DDEC® VI Troubleshooting

NUMBER: 07 DDEC VI-42 S.M. REF.: 109 ENGINE: EPA07 MBE 4000 DATE: December 2007

SUBJECT: SPN 3563

PUBLICATION: 6SE568

Figure 1 Intake Manifold Pressure/Temperature Sensor

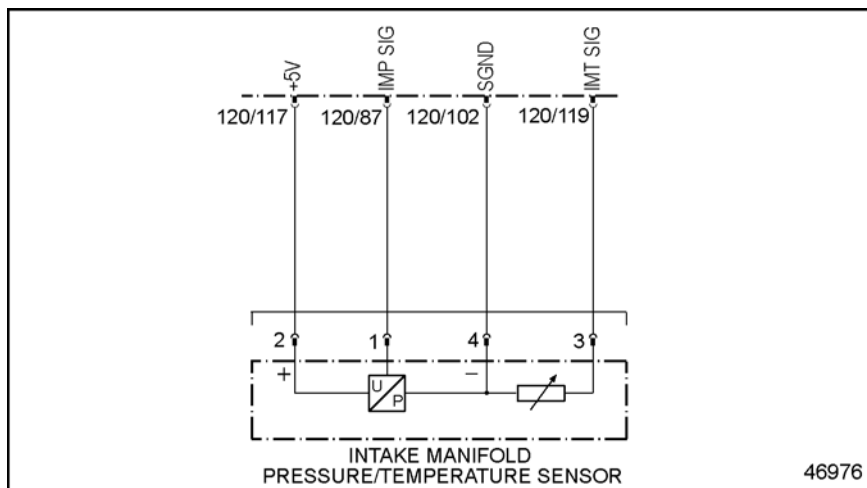
SPN 3563/FMI 4 has changed.

This diagnosis is typically Intake Manifold Pressure Sensor circuit failed low.

1. Disconnect the Intake Manifold Pressure/Temperature Sensor.
2. Disconnect the MCM 120-pin connector.
3. Measure the resistance between pin 1 of the Intake Manifold Pressure/Temperature Sensor and ground.
 - [a] If the resistance is less than 3Ω , repair short to ground between pin 87 of the MCM 120-pin connector and pin 1 of the Intake Manifold Pressure/Temperature Sensor.
 - [b] If the resistance is greater than 3Ω , replace the Intake Manifold Pressure/Temperature Sensor.
